061997-15
	1997-06

MODEL: Chain Saws

SUBJECT: Fuel Line Splits

Part #503 18 49-01
Shown where it is used
in this application.

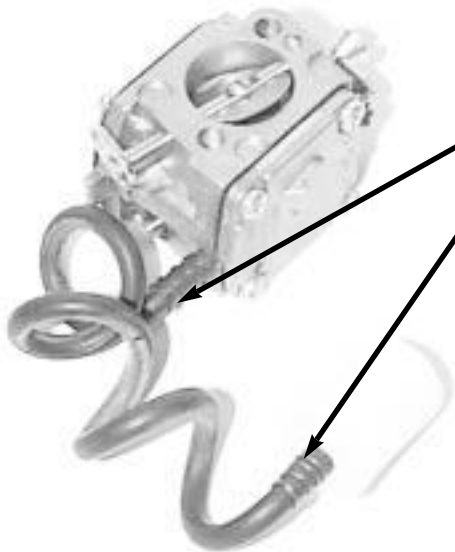
When using some reformulated fuels it has been reported that fuel lines split and the filter comes off, then the fuel line will not stay submerged in the fuel mix in the tank. This can produce erratic running and in some cases lean running conditions. There have also been isolated reports experienced at the carburetor fitting.

Should you encounter this you can use part #503 18 49-01 which can be installed over the line to improve durability. Refer to pictures below.

To install place the spring on the fuel line. Hold spring in place on fuel line while pushing nipple into the line. You may need to twist the fuel line and spring at the same time to make inserting the nipple easier. **Note: A small amount of oil can be applied to assist in installation.**
